Common-Use Lounge Concession at Eppley Airfield

Request for Proposals

Addendum No. 1

June 17, 2025

**Lease Outline Drawing for New Storage Space (see Item 3)**

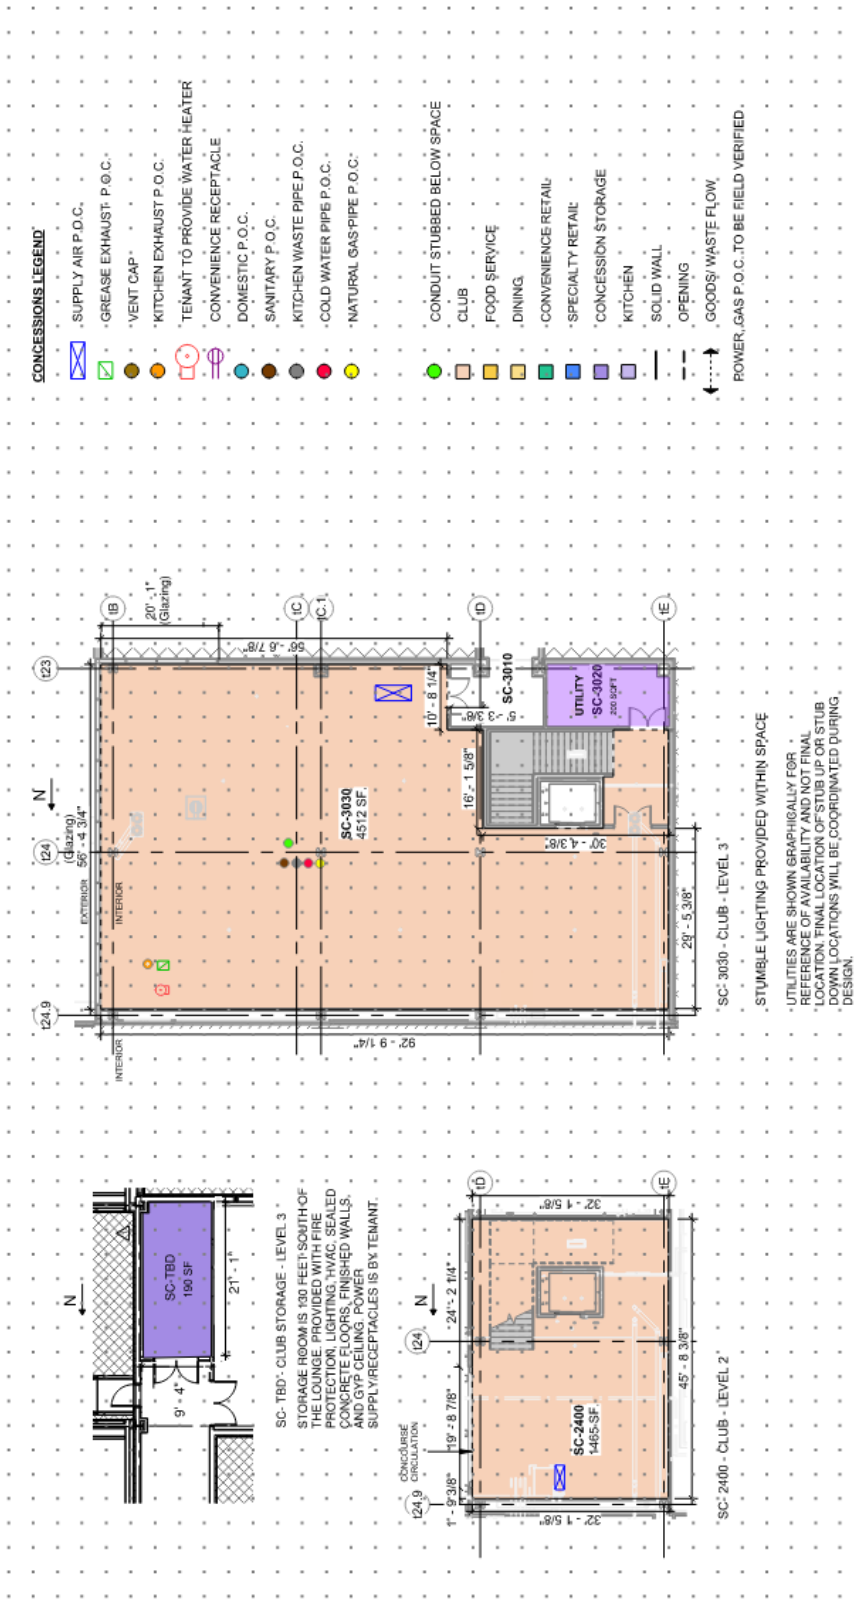
3. The **Concept Description** table in Section 4 of the RFP is hereby revised to replace the Common-Use Lounge – Optional Support Space as follows:

Common-Use Lounge – Support Space			
Lease Term: Coterminous with Common-Use Lounge Lease Agreement			
Unit No.	Sq. Ft.	Additional Information	Target Occupancy Date
SC-TBD	190	Level 3 (adjacent to egress corridor) ⁽¹⁾	Summer/Fall 2026
NC-1104	466	Airside Loading Dock – Level 1 ⁽²⁾	Summer/Fall 2026

Refer to Attachment 1 of this Addendum No. 1 for a Lease Outline Drawing of this space.
